Waste Permits Division Correspondence Cover Sheet

Re: Response to Technical Notice of Deficiency Letter
City of Meadow Landfill
Meadow, Terry County, Texas
Municipal Solid Waste Permit Number: 2293C
Tracking No. 30060987; RN101570976/CN606025534
Major Permit Amendment

NOD 1 TABLE

Figure III-1
Waste Movement Flow Diagram

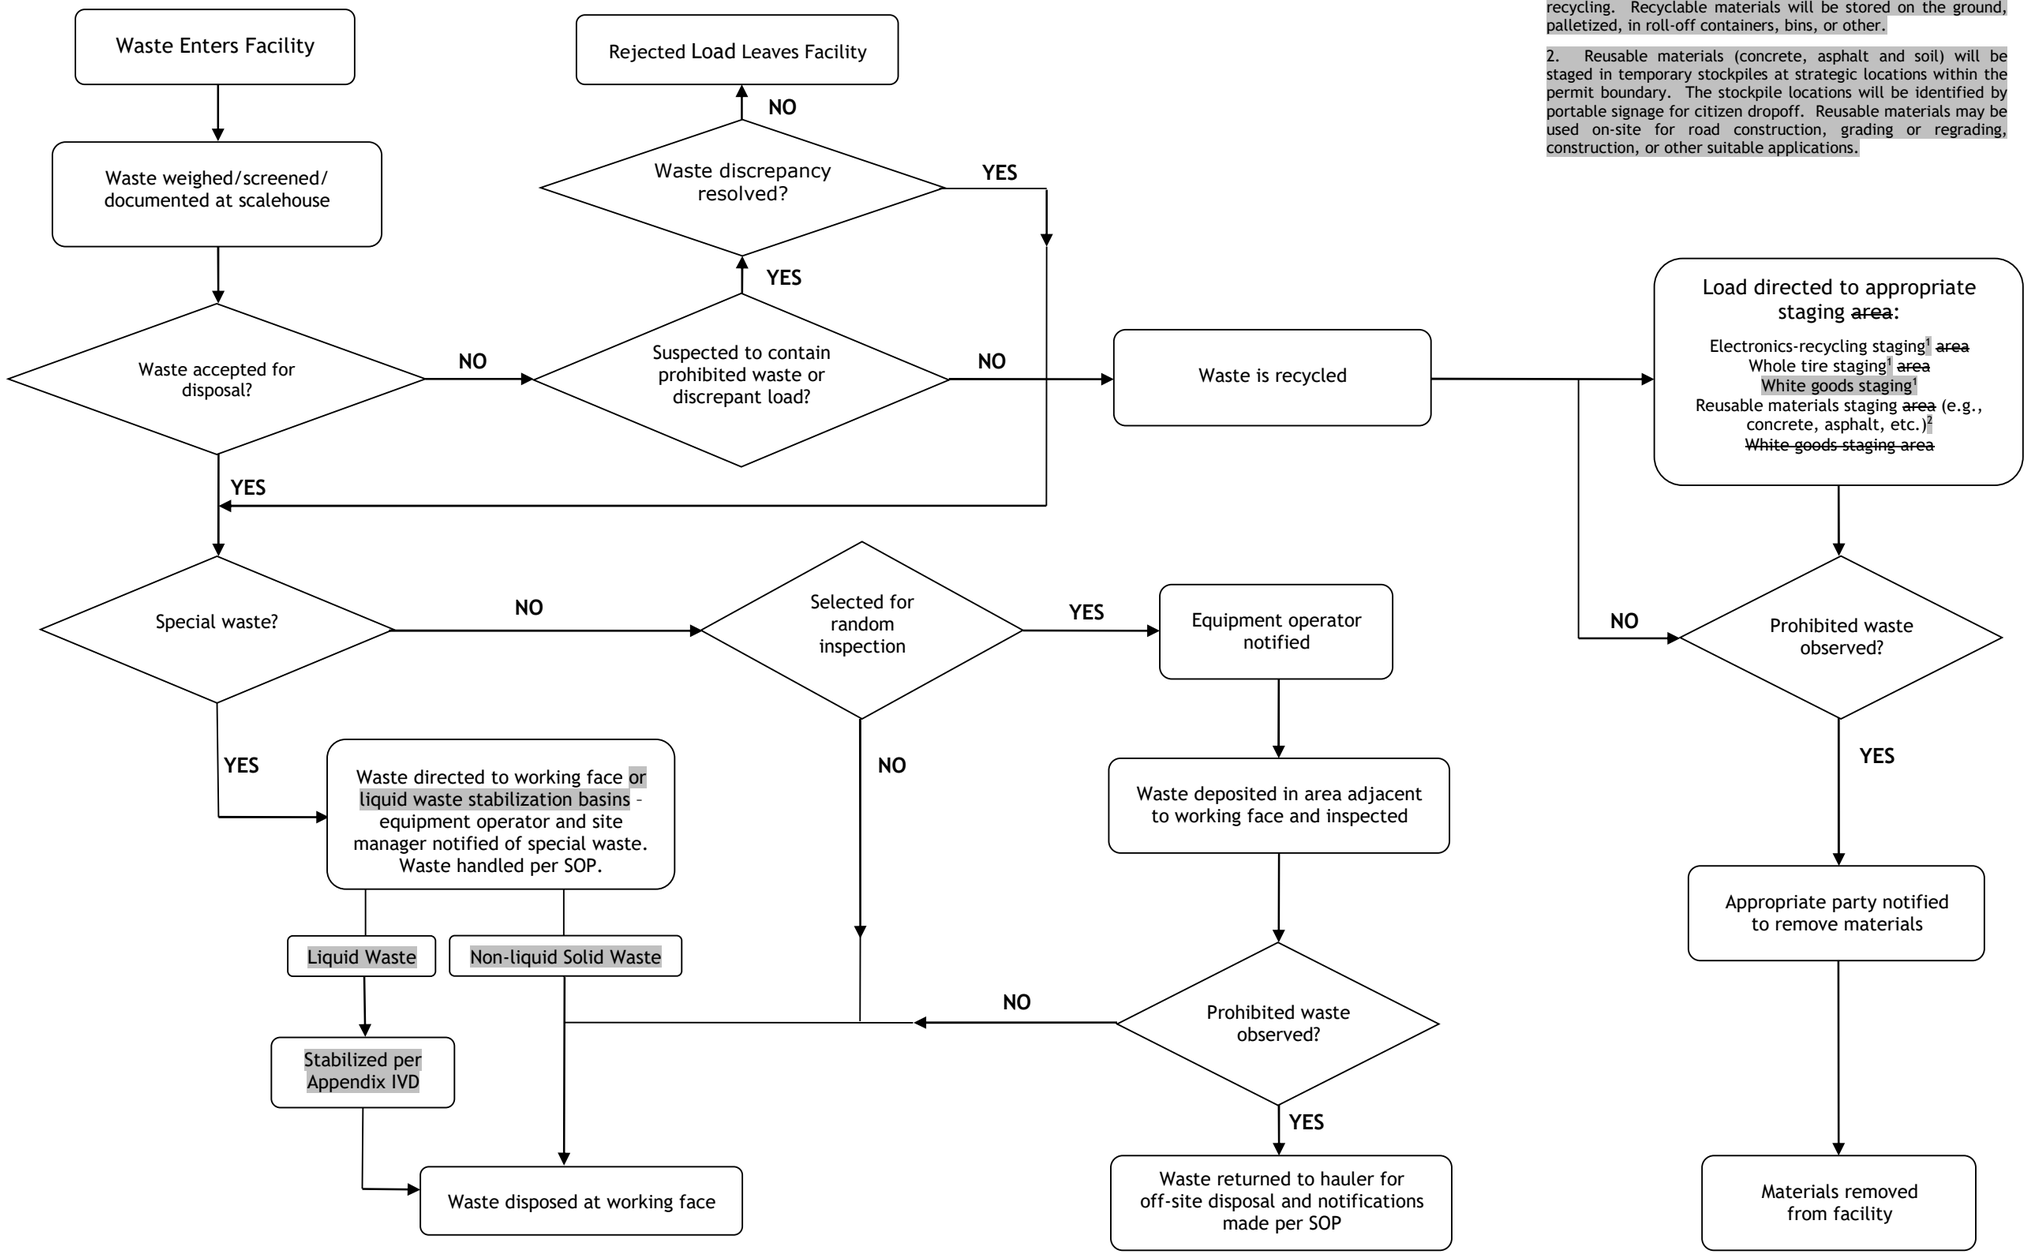
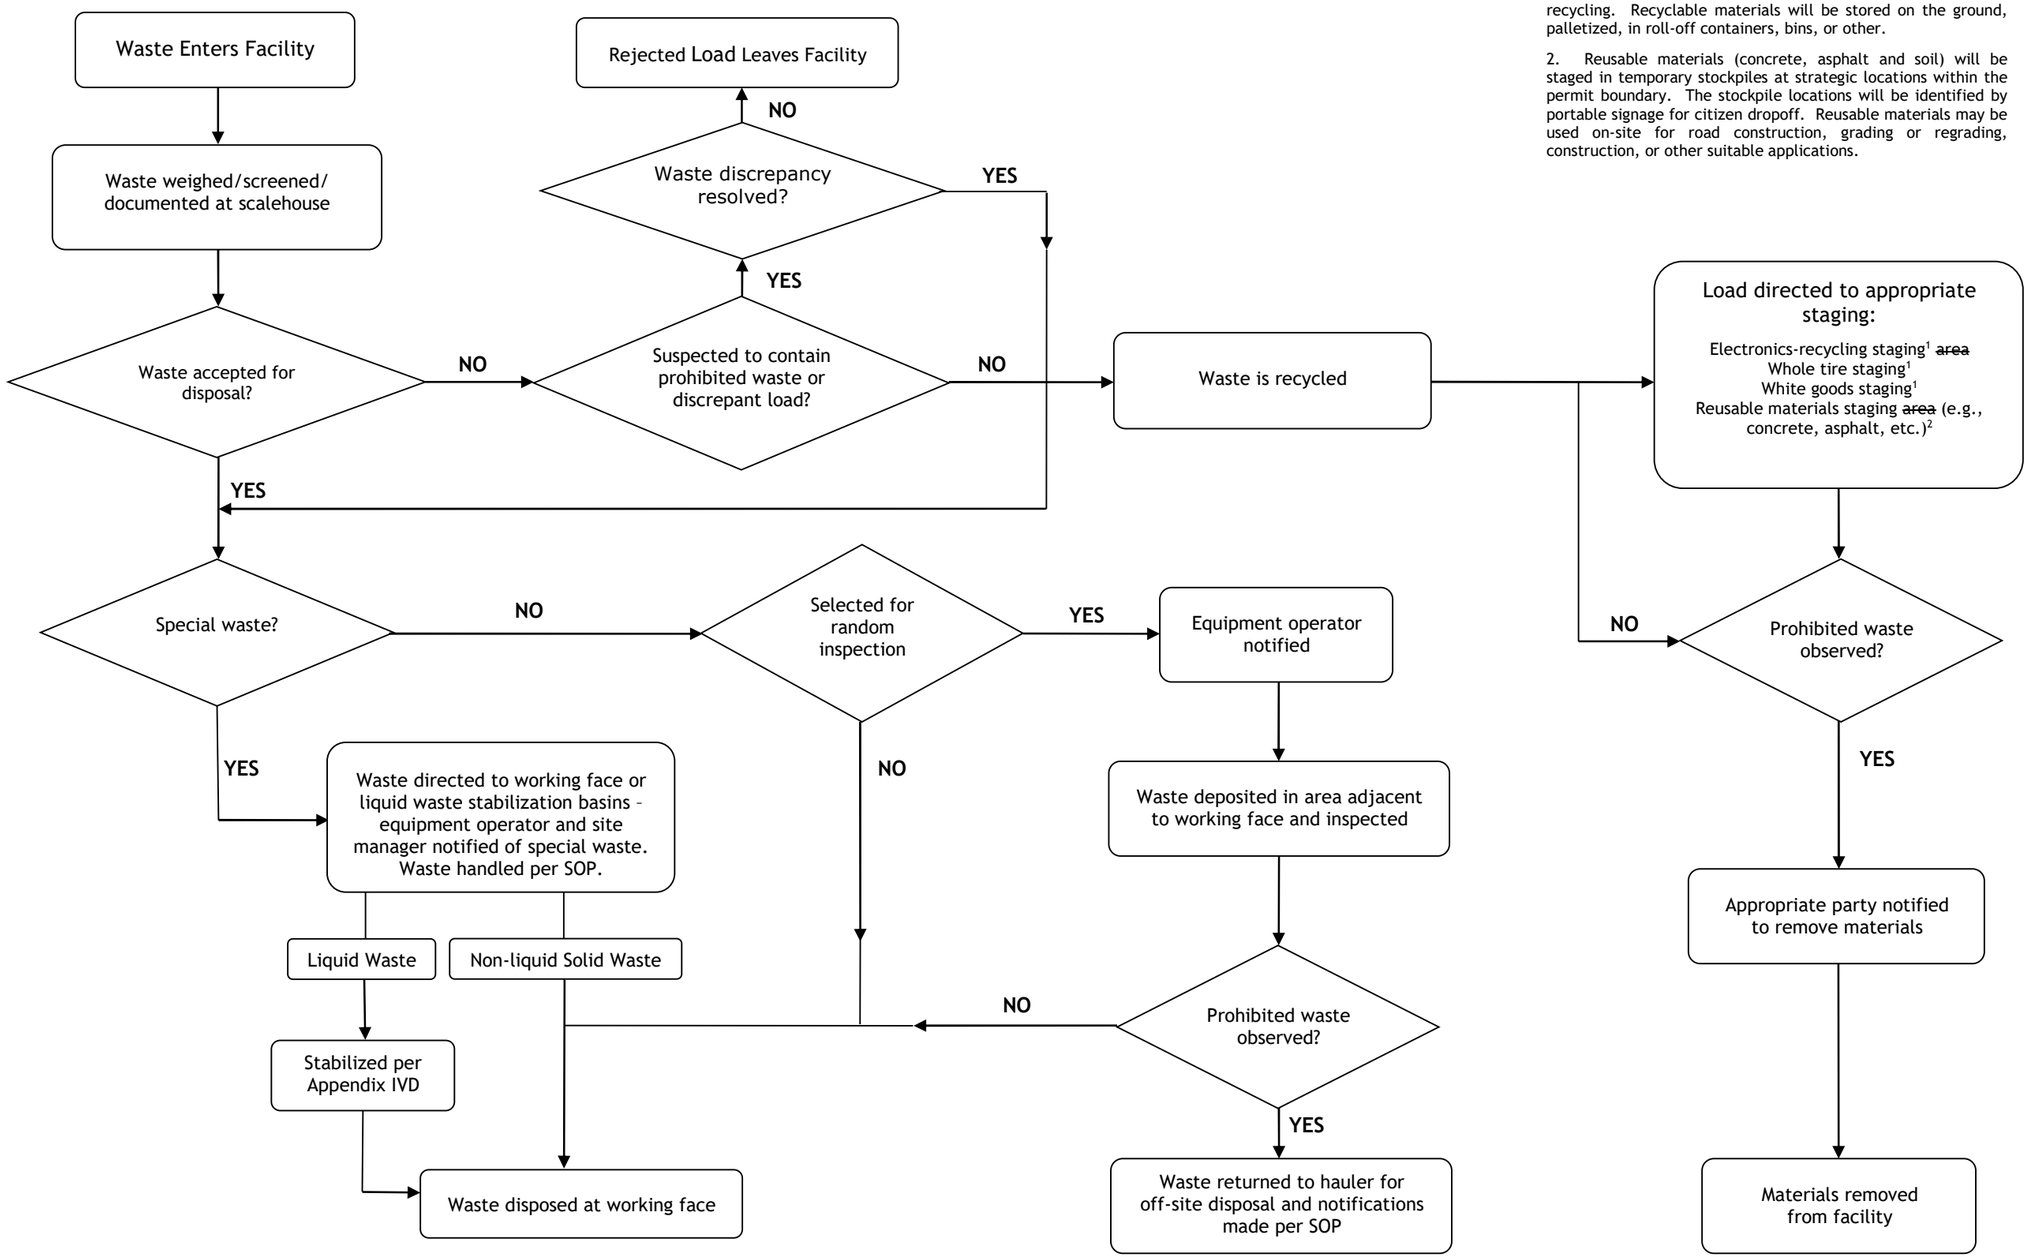
127	272	Part III, Section 2.2.1	330.63(b)(2)(A)	Figure III-1 (Waste Movement Flow Diagram) shows a list of staging areas. Revise to remove the staging areas which operations are not specifically identified and addressed in Part IV, SOP, or add these to the SOP. Revise drawings in Appendix I/IIA (and in other relevant portions of the application) to show the locations of the staging areas that are properly specified in the SOP. **Response:** Figure III-1 has been revised to clarify that the recycling staging will occur at the Citizens Convenience Center, with asphalt, rock and soil delivered to the site

FIGURE 4.5

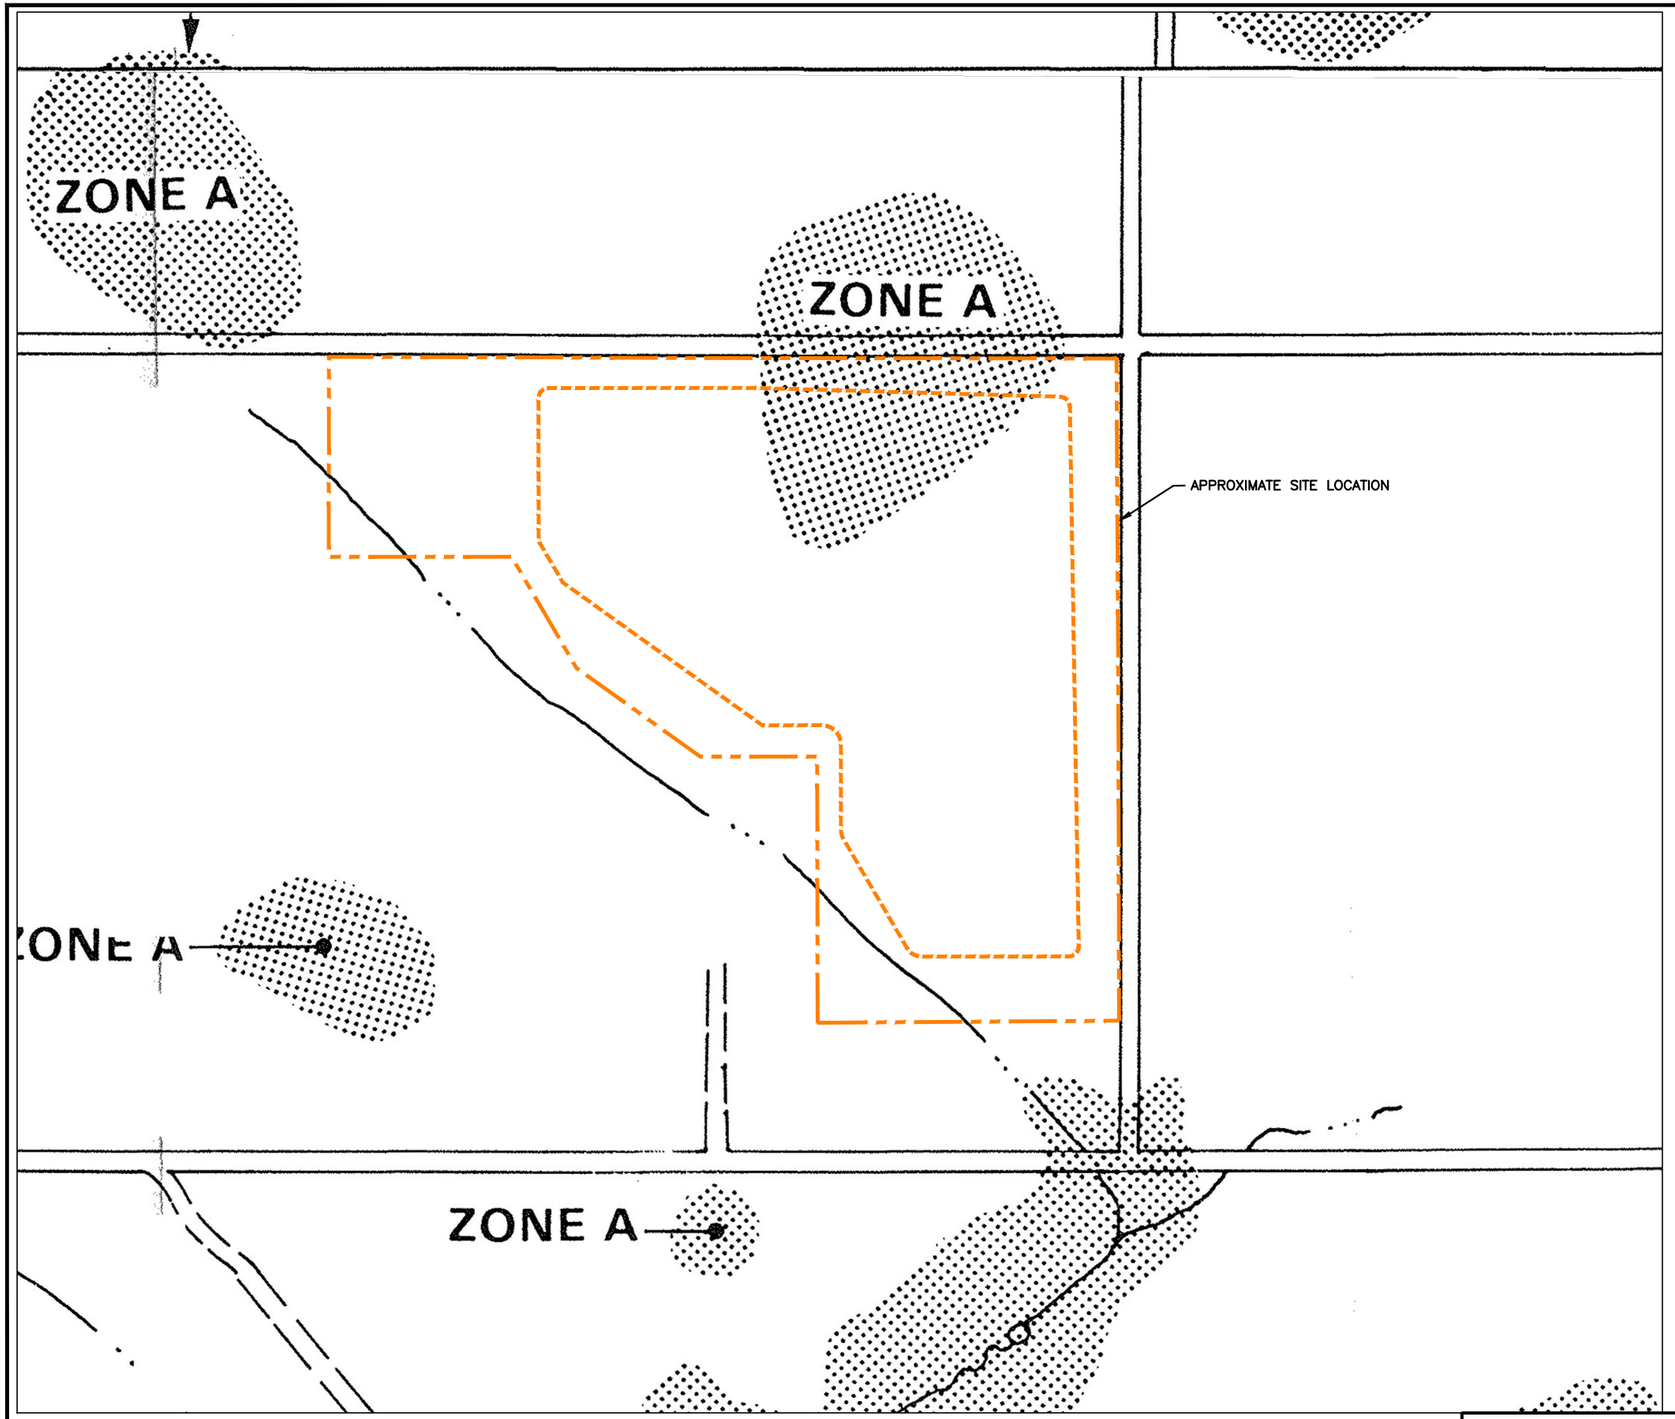
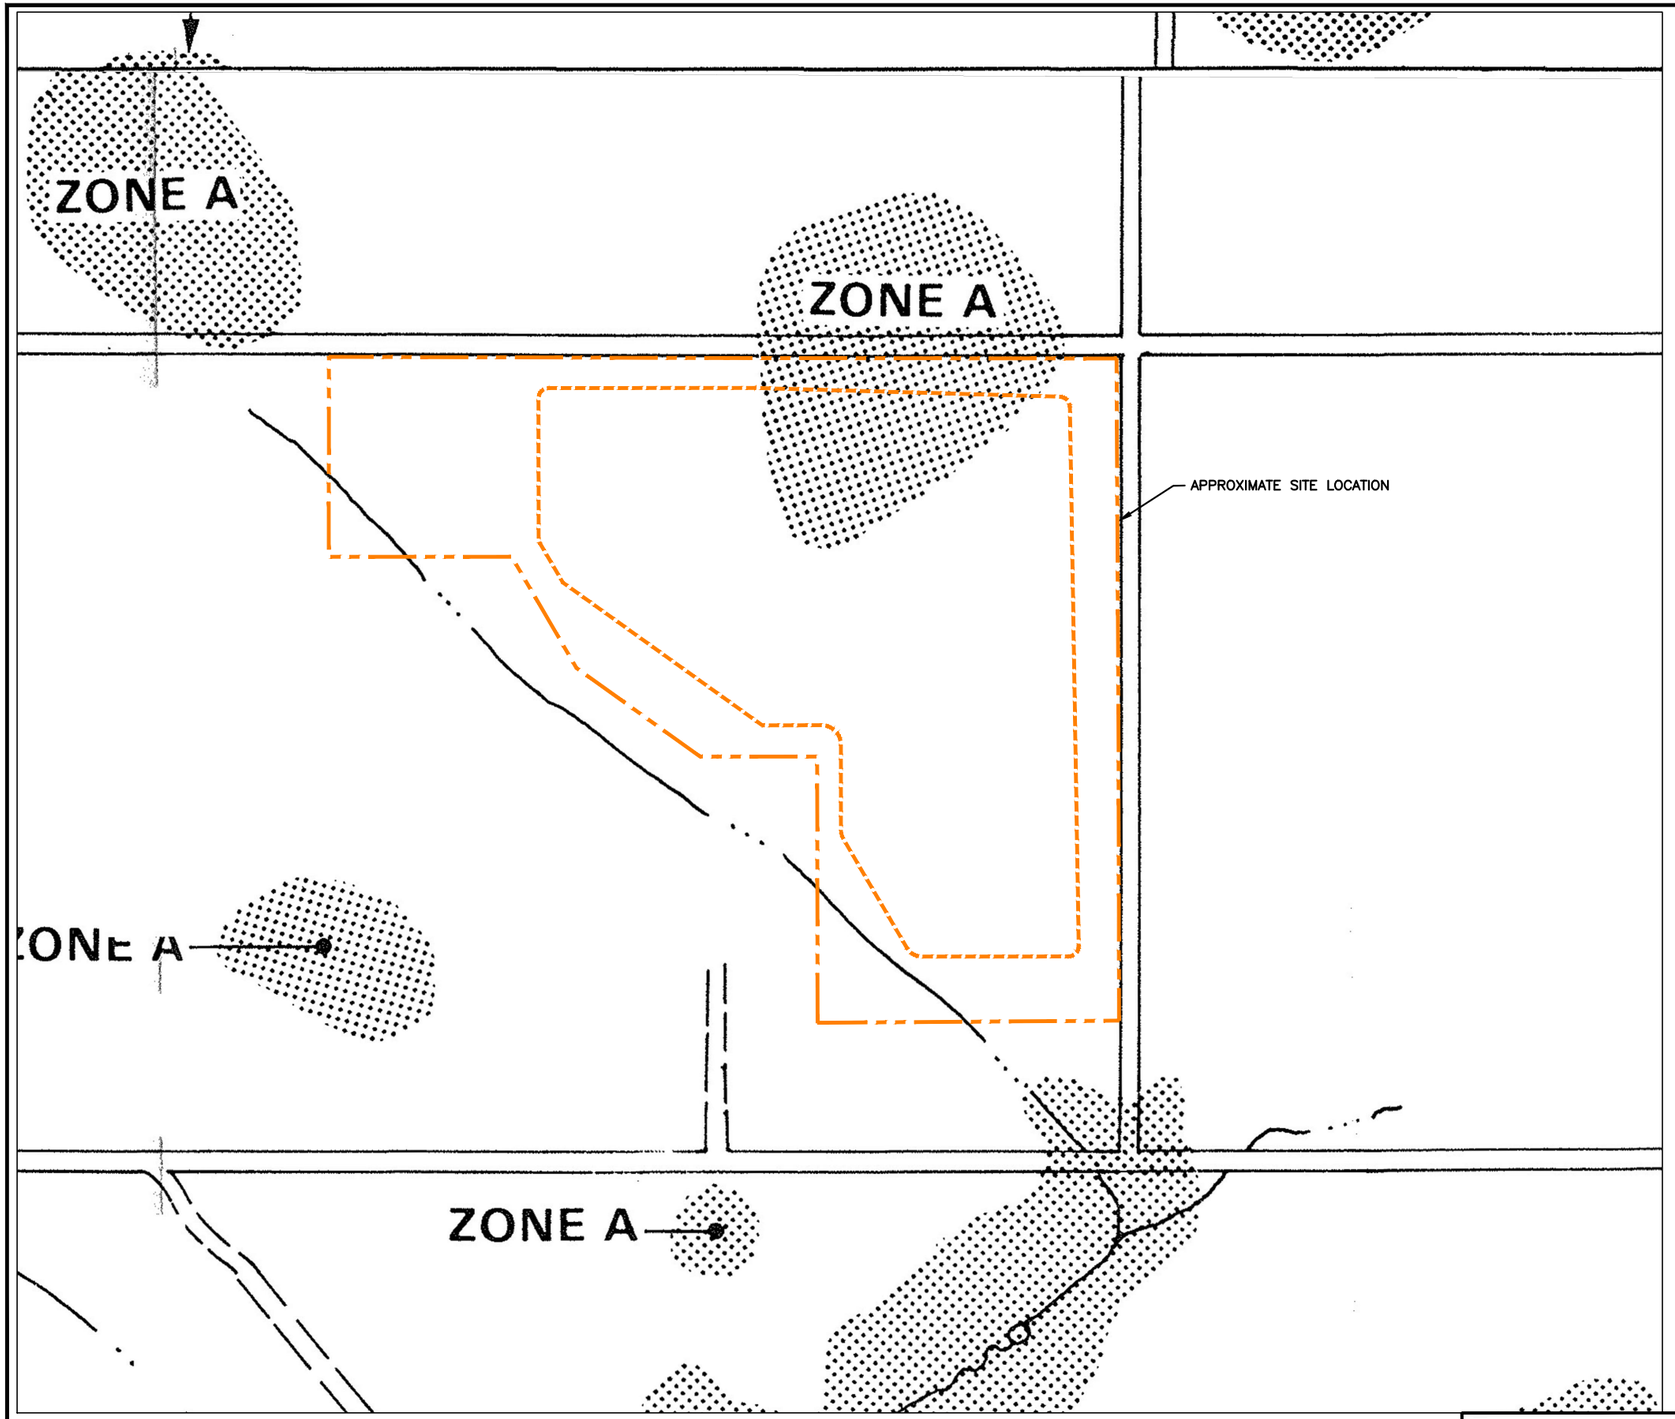
138	312	Part III, Appendix IIIF, Section 4	330.63(c)(1)(D)(iii)	Revise Figures 4.4 and 4.5 of Appendix IIIF to clarify if DP3 under the post-development pattern is the discharge from Detention Pond 2. Revise to clarify the flow conditions (sheet flow/overland or concentrated or channelized) at DP1, DP2, and DP4; and reference their discharge structure design as necessary. Discuss erosion prevention measures at these discharge points/areas. It is noted that Section 2.1 of Appendix IIIF states, "Currently the site sheet flows toward the south." **Response:** Callouts were added to clarify DP3 is the discharge location of Detention Pond 2 to Figures 4.4 and 4.5 in Appendix IIIF. As stated in Section 4.4 of Appendix IIIF, the existing drainage patterns will not be altered by the proposed development. Evaluations of flow rates, volumes, and velocities at each discharge point are discussed in Section 4.3, Table 4-1, and Figures 4.4 and 4.5. Currently, the site generally sheet flows to the south, as there are no constructed channels to concentrate runoff.
